Environmental Impact Assessment

Screening according to Schedule III of S.L. 549.46

ERA Reference no.: EA/00012/24

Project Title: Construction of underground basement parking, Showroom at ground floor and Offices Class 4A at upper levels with a different layout from that approved in permission PA/1017/09. Changes include addition of one basement level for parking and a receded level for Office use

Figure 1 – Location of the site (Source: PA Geoserver)

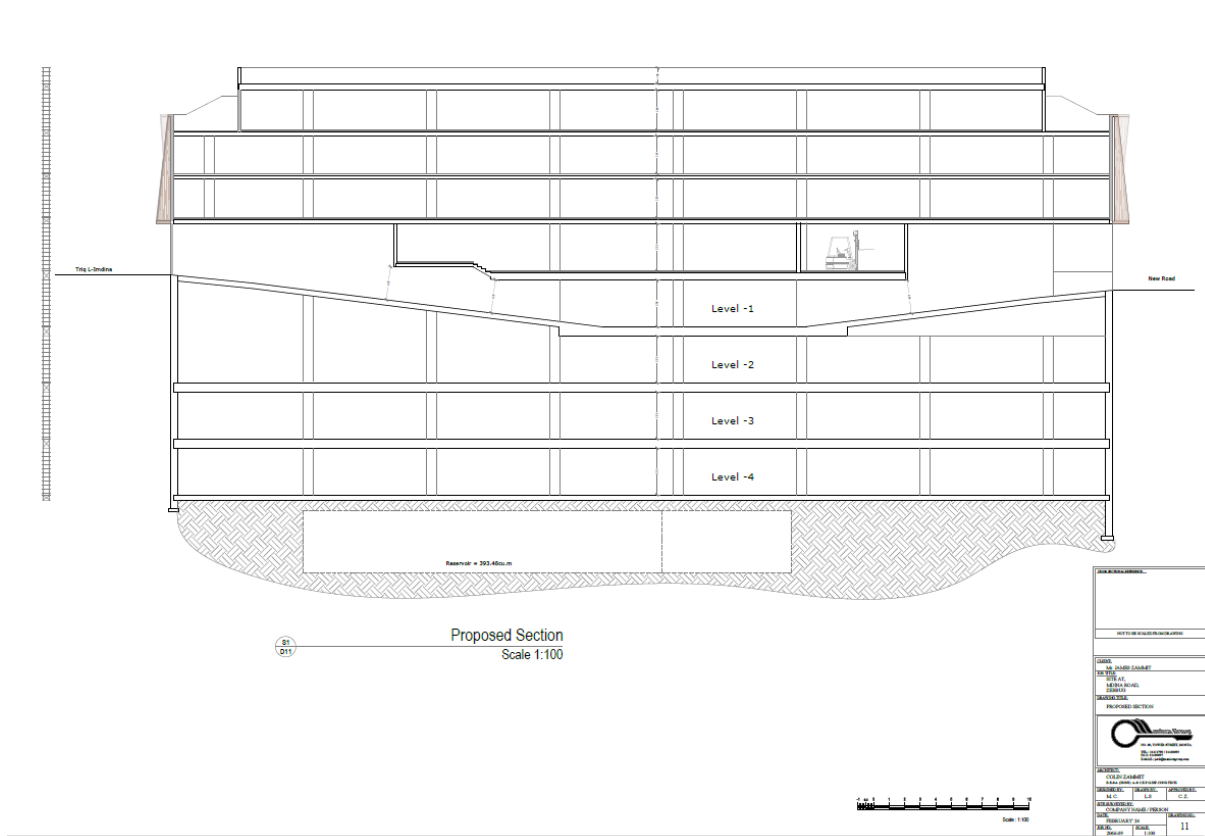
- 1.1 This proposal seeks to develop a vacant site (figure 1) with a site area of c. 1,779m² and a gross floor area of the 15,336 m² consisting of an underground basement parking, a showroom at ground floor and three level of offices with a different layout from that approved in permission PA/1017/09. The roof of the proposed development will be utilised for PV panels.

- 2.1 The proposal is located in a vacant site, which has been already excavated as per para 1.2 and is currently occupied by a variety of trees and shrubs located on Triq l-Imdina. The PDS states that even though a formal tree survey has not been conducted, there is some overgrown vegetation on site that shares characteristics consistent with *Prunus* spp., *Ficus* spp., and *Arecaceae* spp. The vegetation currently present on site will be removed by the applicant before commencement of works.
